Modification of Development Consent

Staged construction of the Southlands Warehouse Estate

Modification Application: SSD-9691-Mod-1: Modification to revise the design of the approved elevated concrete platform

The Land: 28 McPherson Street, Banksmeadow, Lot 9 DP 1205673

Figure 4: Overall Pile Plan

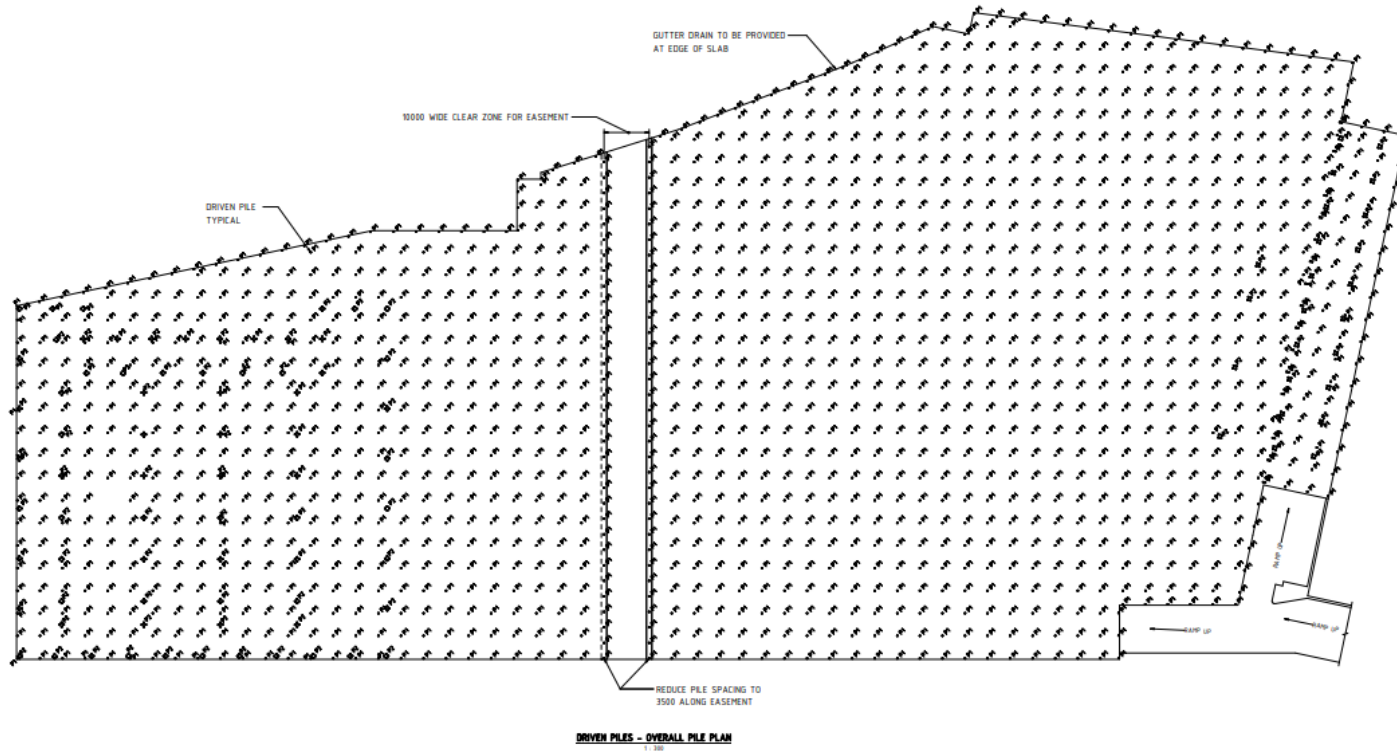
6. In Appendix A – Development Plans, insert new Figure 4 after Figure 3 as shown in Attachment A of this modifying instrument.
